AGENDA OF THE PLANNING
COMMISSION
CITY OF BIRCHWOOD VILLAGE
WASHINGTON COUNTY, MINNESOTA
August 22nd, 2024
7:00 P.M.

Re: Appeal of City permit issued for 160 Cedar Street

MEMORANDUM

CERTIFICATE OF SURVEY

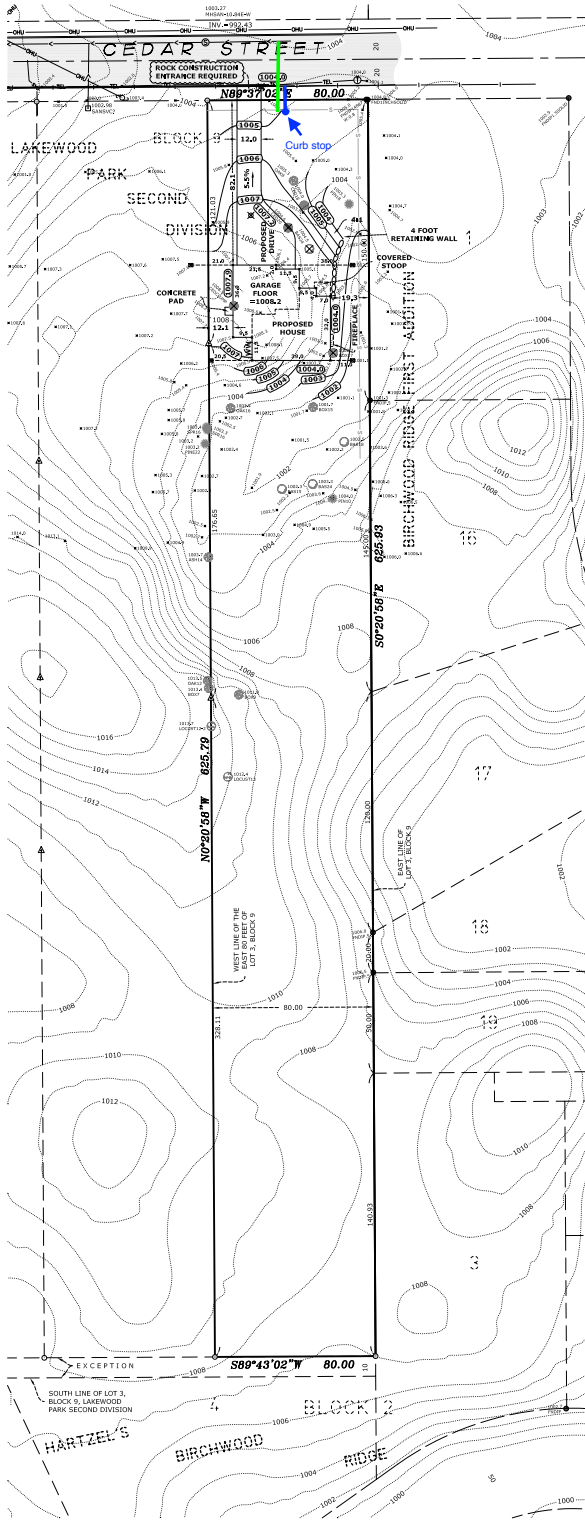
Per the builder's survey dated 4/25/2024, the increase in impervious surface is 3500 square feet. Much of that impervious surface will drain directly onto our property. There are no

containment provisions included in the plan, nor are there any calculations for runoff or analysis of any soils to determine the infiltration rate of storm water.

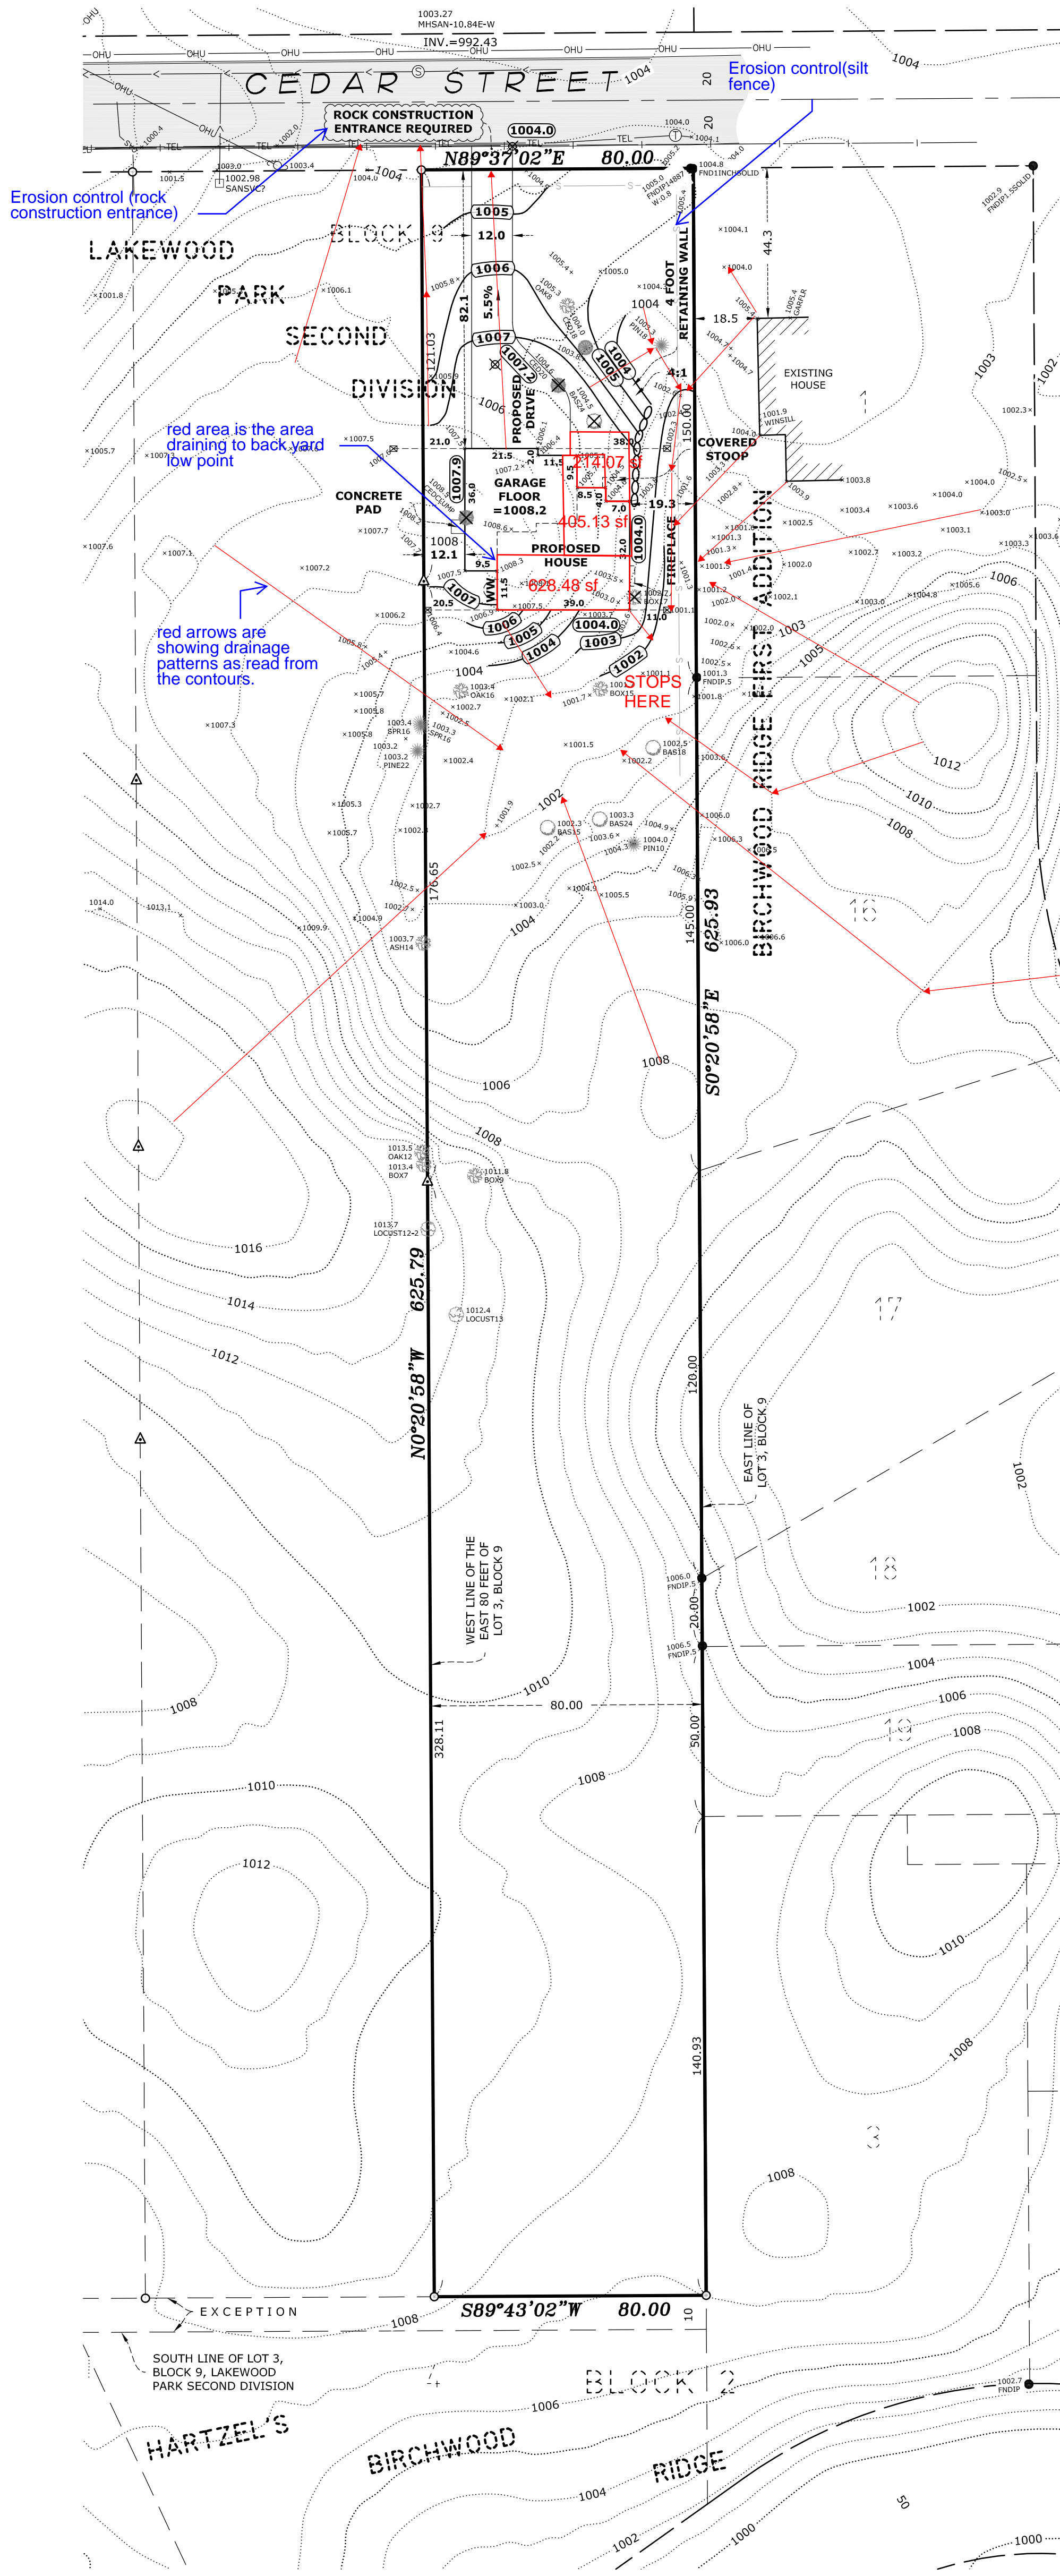
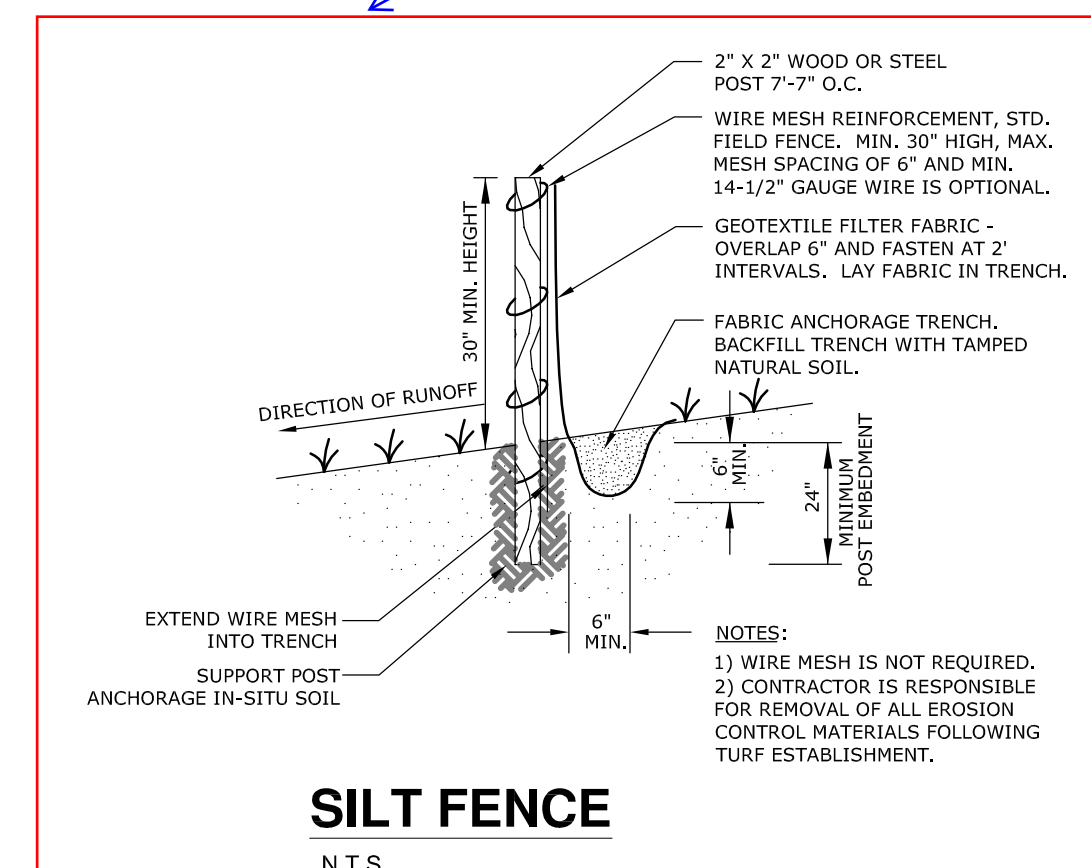
1. "Birchwood Code 301.055 (7) Stormwater and erosion control plans. For a building permit, the applicant must submit stormwater and erosion control plans prepared and signed by a licensed professional engineer." This has not been done.
And "The stormwater management plan must detail how stormwater will be controlled to prevent damage to adjacent property". There are no drainage control structures or any provision for impoundment/containment of water at and within 160 Cedar Street.

2. "Birchwood Code 301 NOTE: A separate Conditional Use Permit is not required for a land disturbance activity in conjunction with construction as part of a building permit as granted. However, as part of the Building Permit application, the applicant shall provide information required pursuant to Section 306.030 and shall follow all provisions of Section 302.050...and 302.055".

part of the erosion control suggested was missing

impervious calculations

- a. As far as I am aware, the city has granted the option of a licensed engineer or a surveyor. It is signed by a licensed surveyor.
 - b. Due to the nature of the project it was not required to be signed off by a licensed engineer on the plans.

- c. Erosion control is on the survey drawing and is following the MPCA requirements as far as BMP's (Best management practices) are concerned. See attached survey document.

- See survey attachment where drainage arrows have been applied. If you follow my drainage arrows (if constructed per plans), drainage would follow near the property line but not cross.

In summary, Bolton and Menk received the attached survey and the building layout, traffic control plan, and the permit itself. Most of the site's drainage is reviewed from the survey drawing. To determine which portion of the house drains off to the back of the property, it was required to review the building layout. The city code requires storm water management for all new impervious surfaces. However, it is not as clear as to what level of management is needed when the impervious percentage is less than 25% across the site. As shown in the survey, this property is proposed to only have 7% of surfaces be impervious on the property. The code also does not cover what level of treatment is needed for the stormwater runoff that comes on site from surrounding properties and whose responsibility it is to manage. The permit was approved since the low point was onsite with no variance or conditional use permit. If the permit showed 25% or more impervious onsite or if the drainage left the site, a more in-depth management plan would be asked of the 160 Cedar permit. At that point, a SWPPP signed by a licensed engineer would also be required assuming calculations that would need to be signed off would be involved.
